WIESE INDUSTRIES

APPLICATION BULLETIN

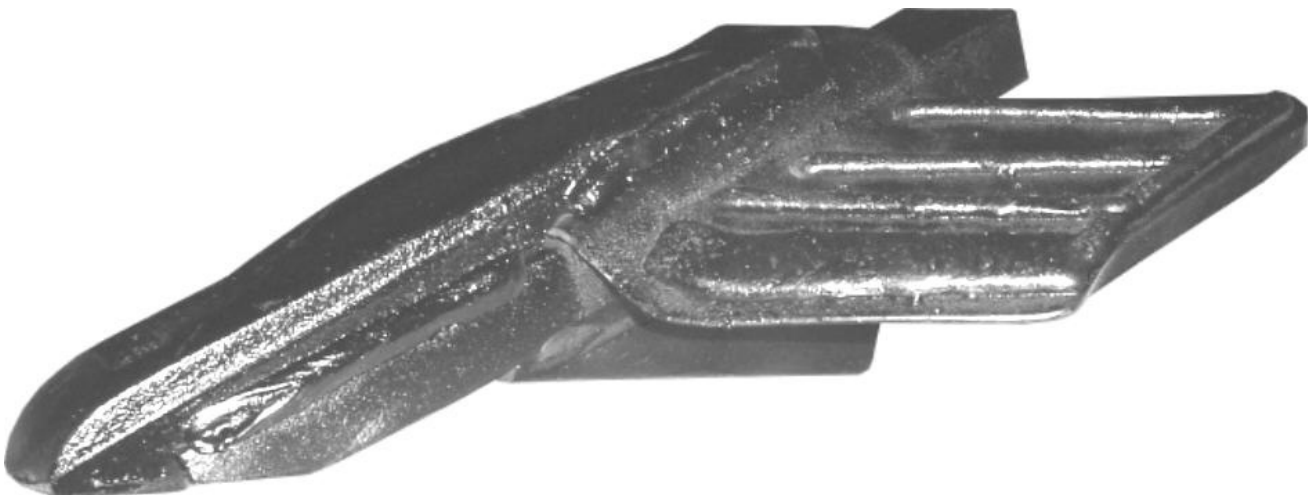
Wiese Industries has discovered that our part # 41BDMI711440 can prematurely fail when used on JD 2700 Mulch Rippers due to the unique configuration of the ripper shanks.

We are recommending discontinuing use on these machines.

41BDMI711440 (right) can still be used on all DMI 1-1/4" shanks and also on JD machines other than the 2700 Mulch Ripper.

Wiese Industries recommends that users of JD 2700 Mulch Rippers install part # 41B2512JDW742 (below). This point is designed specifically for use on all JD 1-1/4" ripper shanks.
